LOST CREEK ISR, LLC

**Re: Annual Report of Changes, Tests, or Experiments Pursuant to License Condition 9.4(E)
Lost Creek ISR Project
License SUA-1598 Docket 40-9068**

Attachment 1: SERP Summary
2016 Annual Report of Changes, Tests, or Experiments
Lost Creek ISR Project SUA-1598

FIGURE 4.1-3
Ventilation Diagram
Lost Creek Permit Area

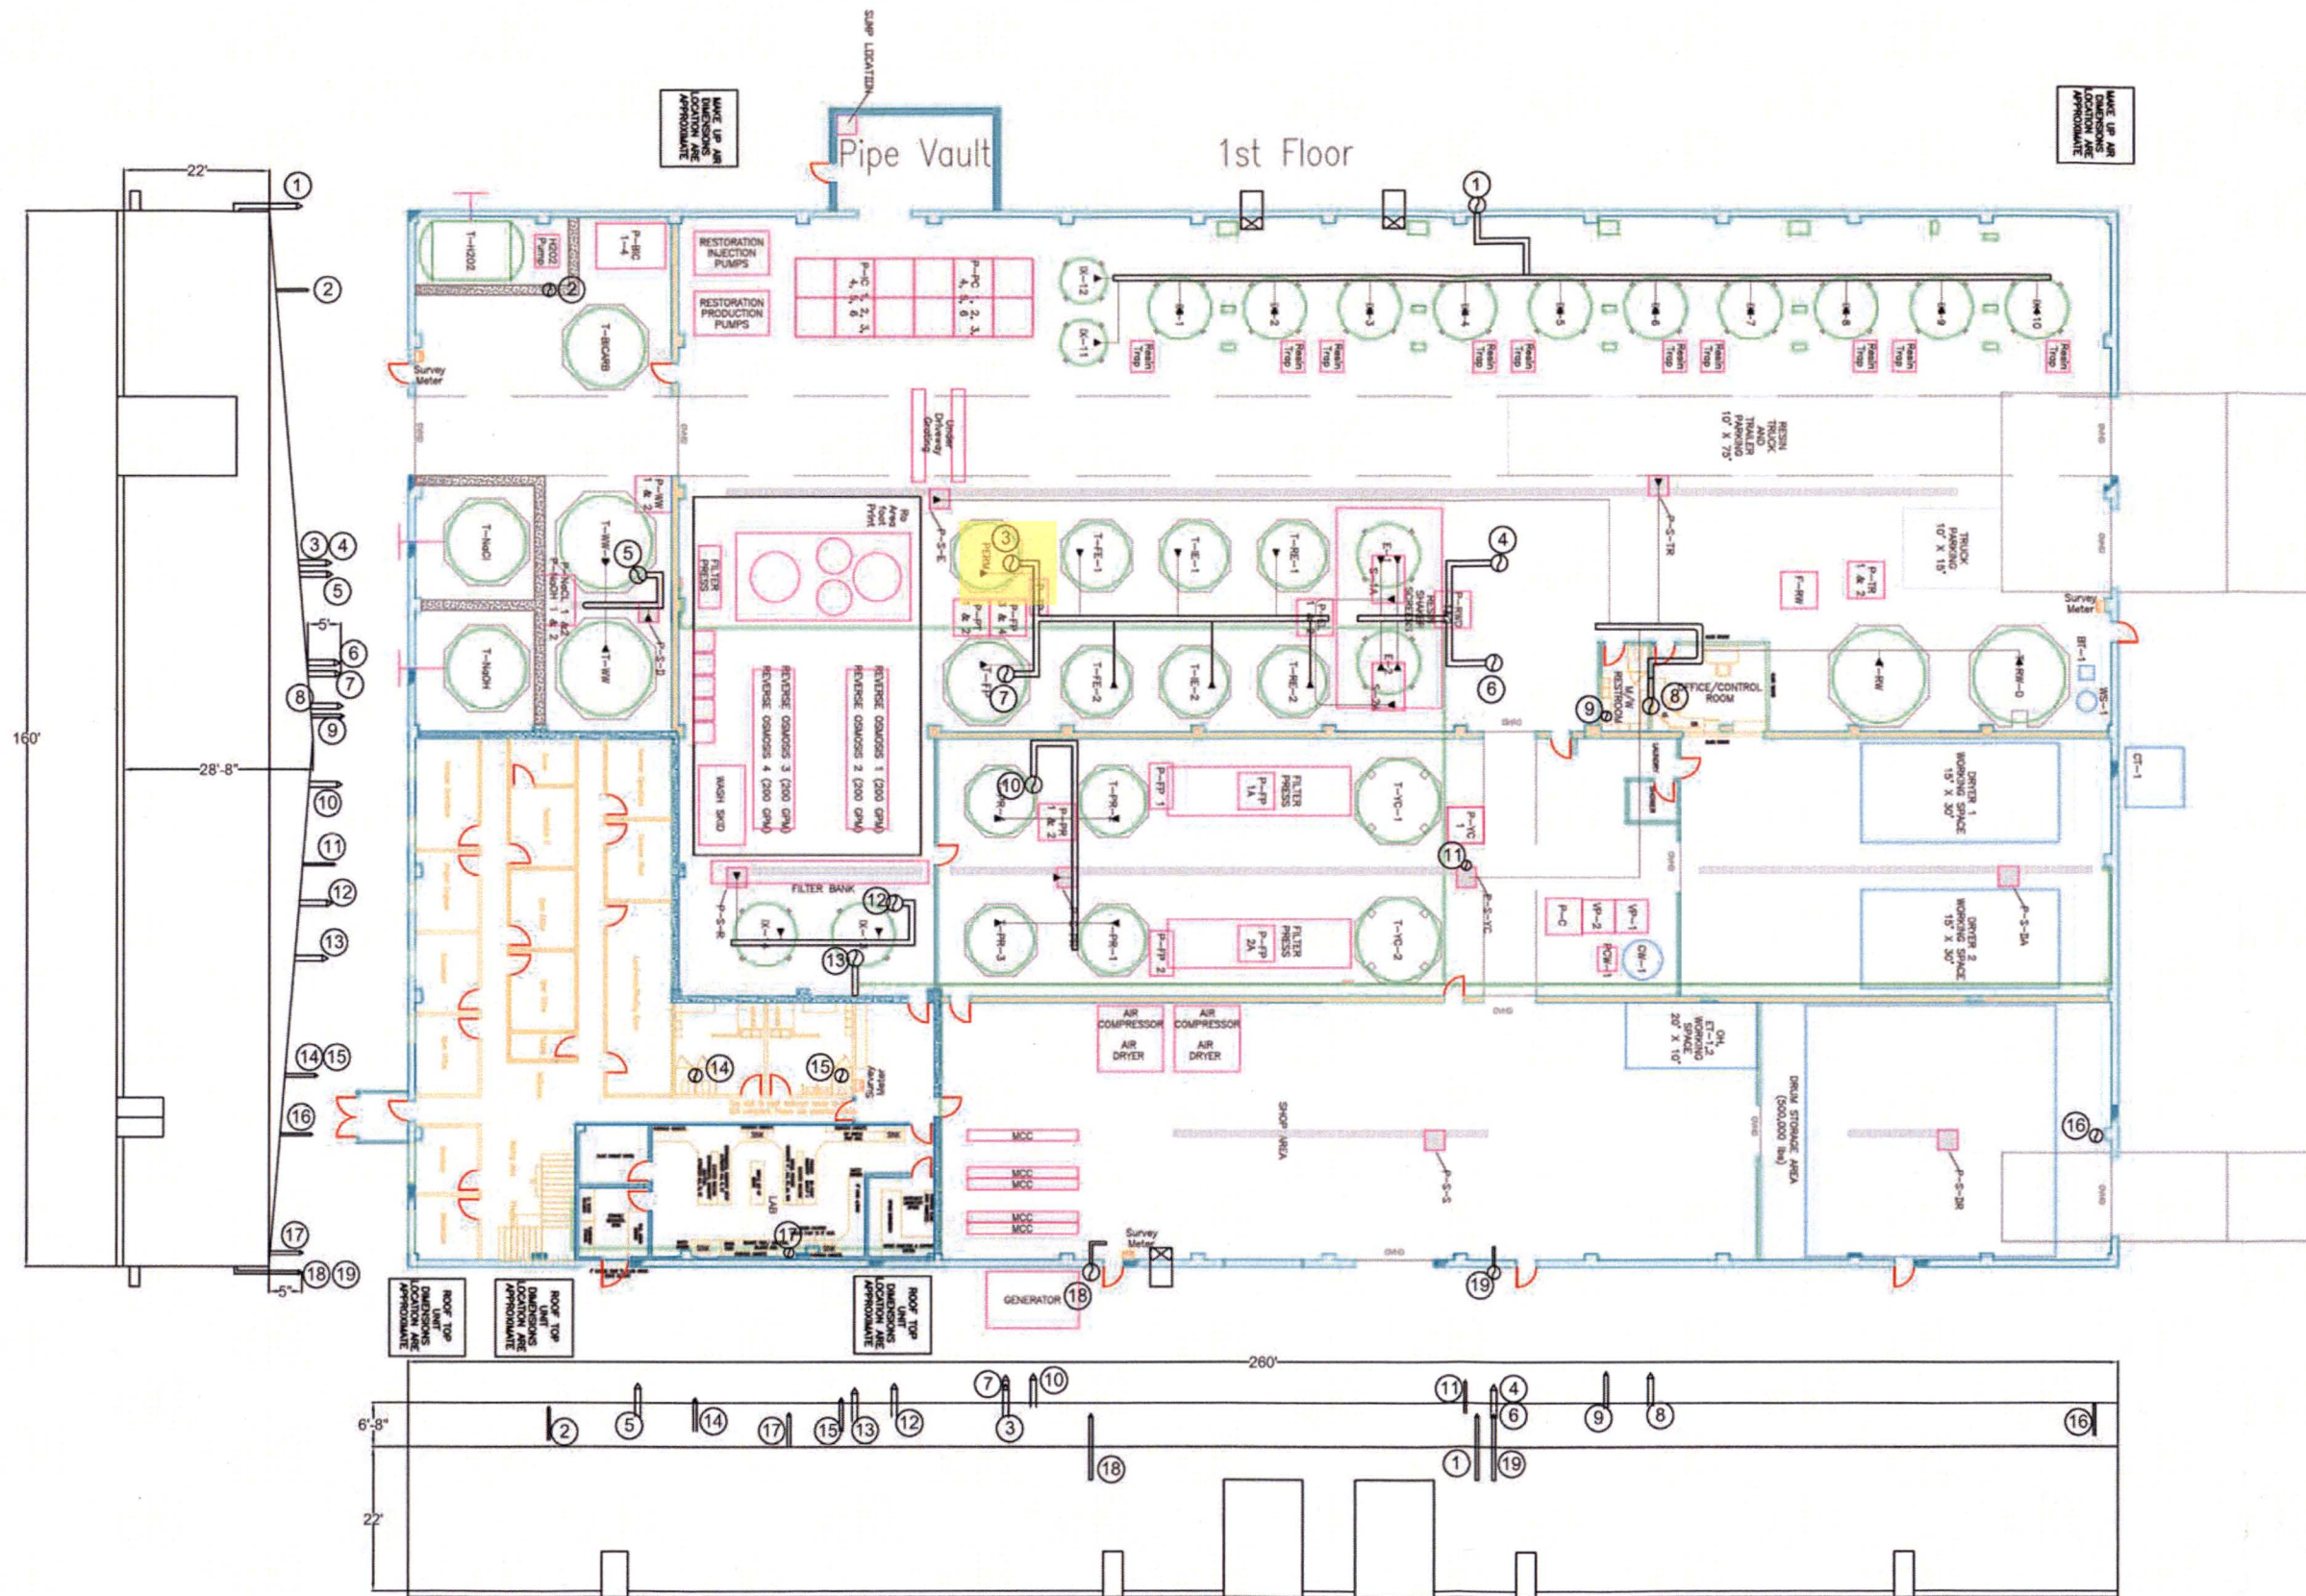
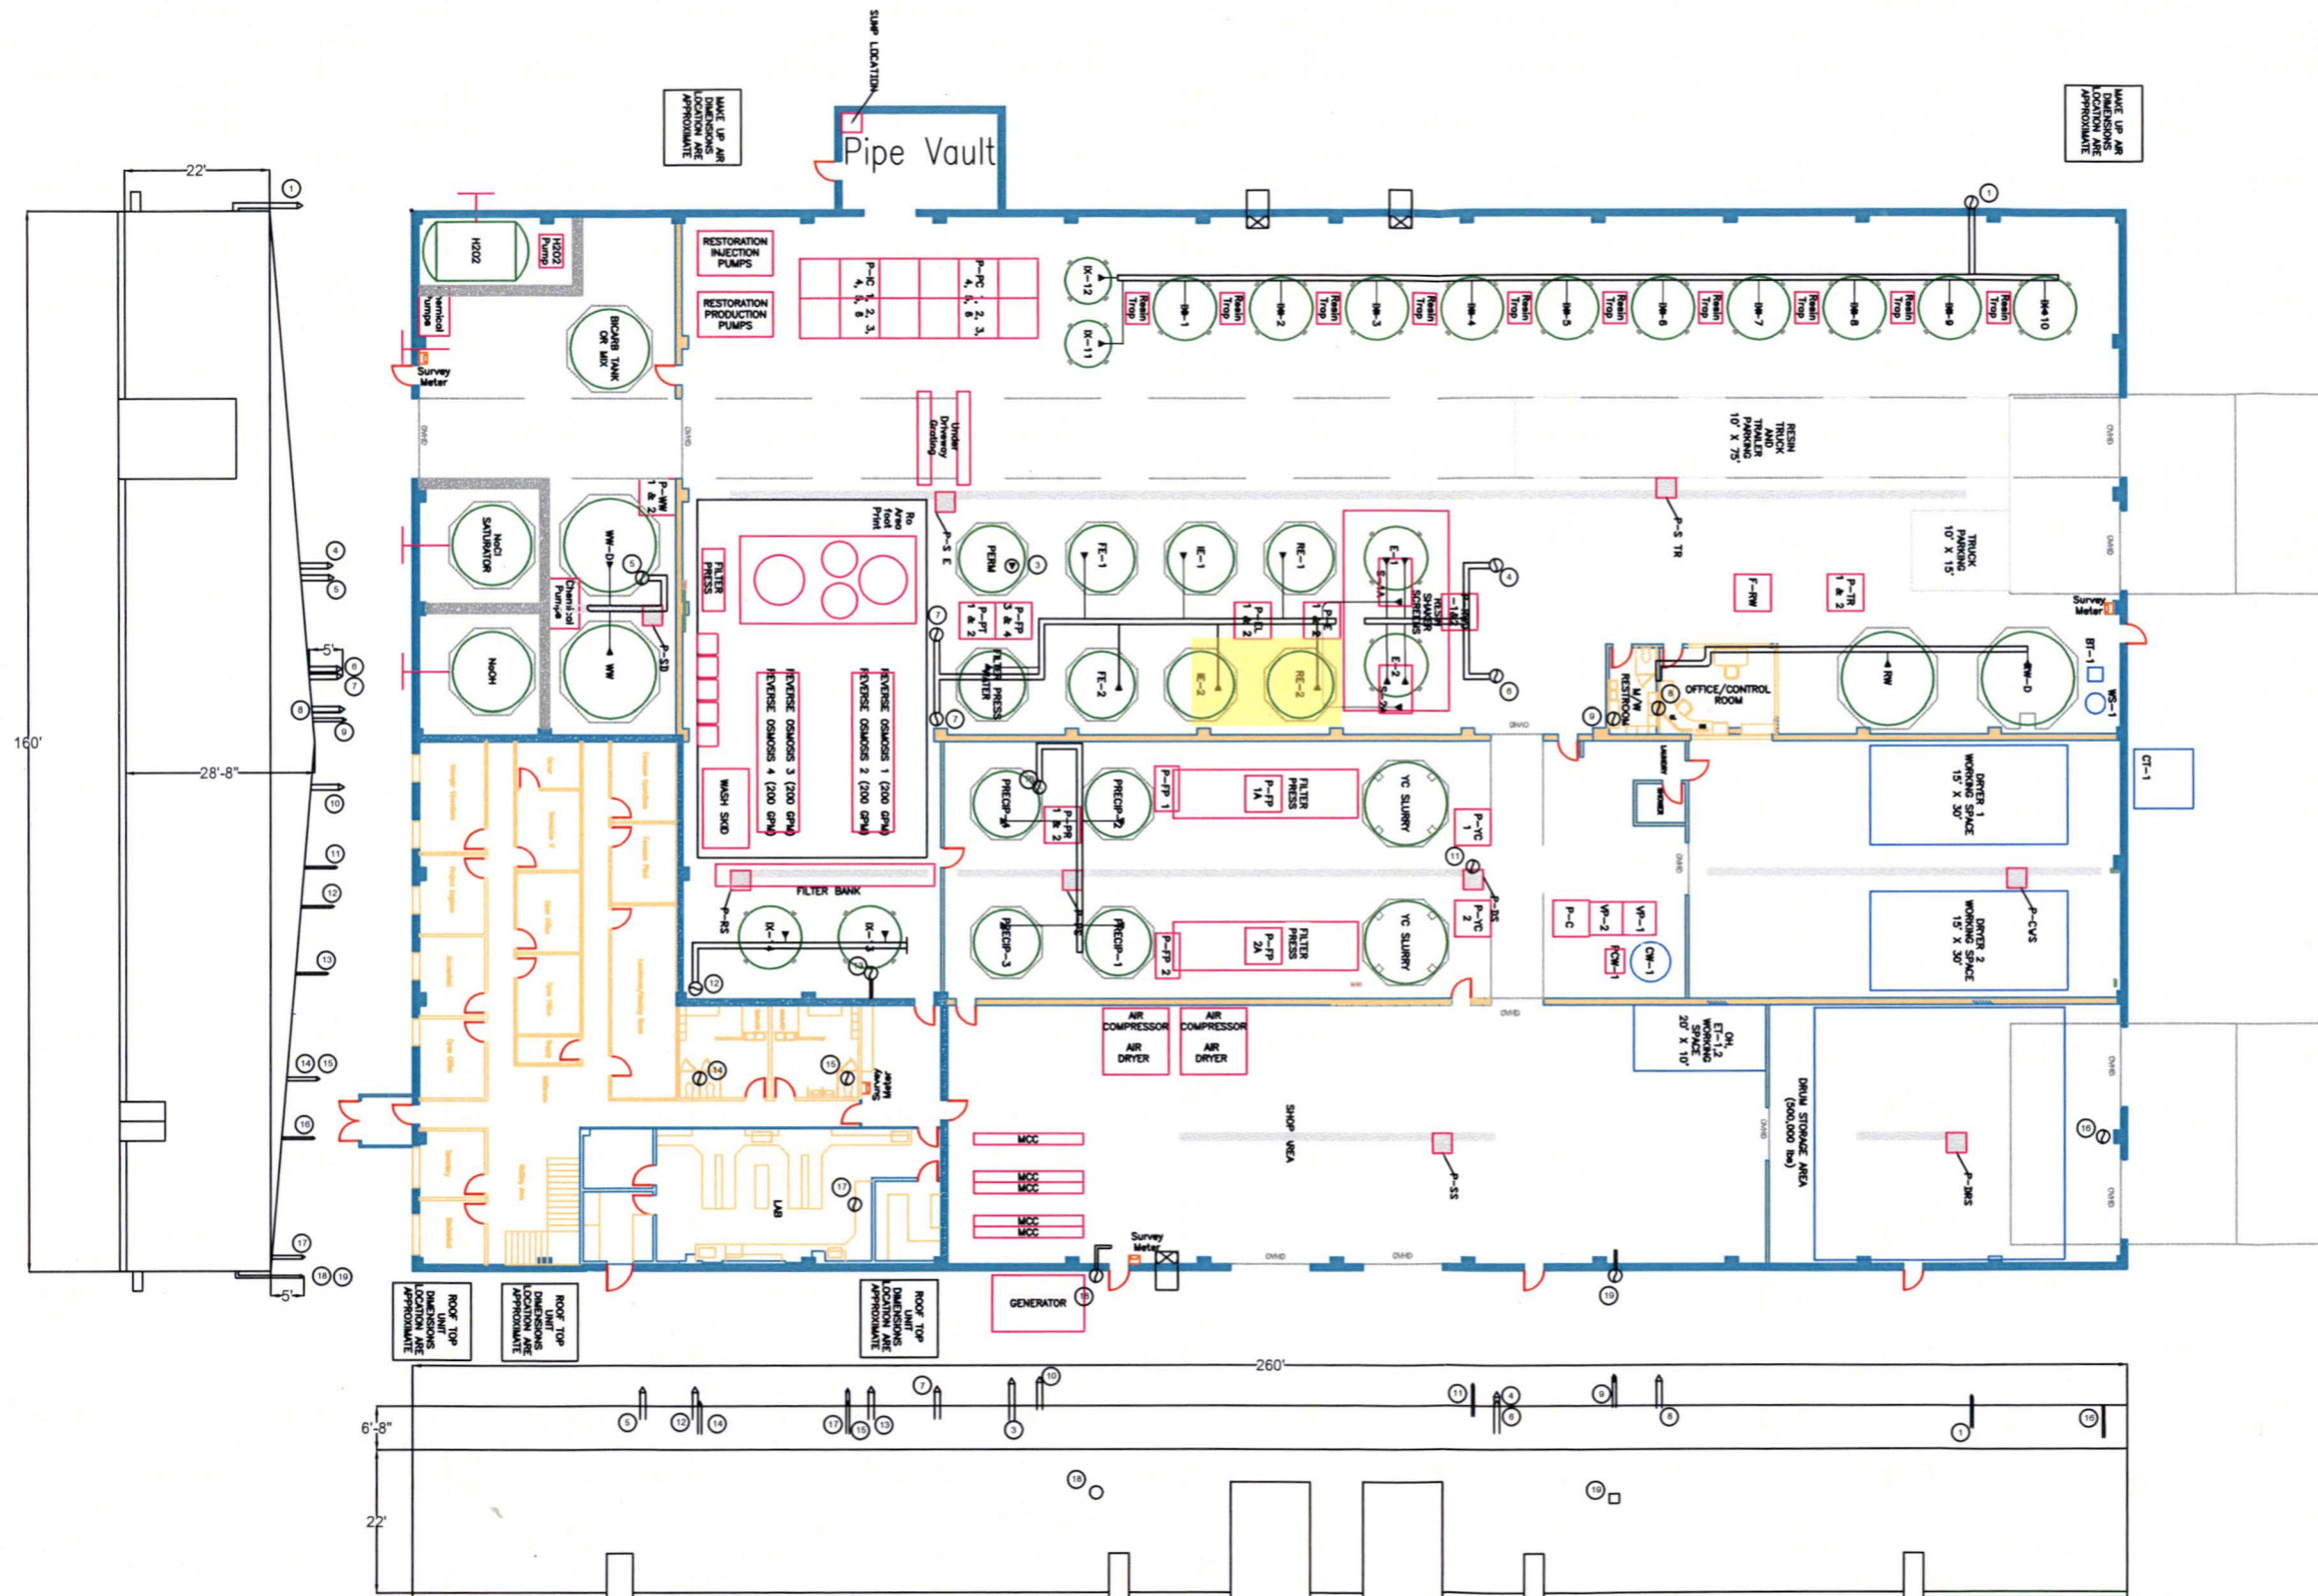
4	Dec 2016	Technical Report Section 4	Figure 4.1-3 (Jun16)	Figure 4.1-3 (Jan17)	Added vent modification for IE2 and RE2 tanks	SERP LC16-11
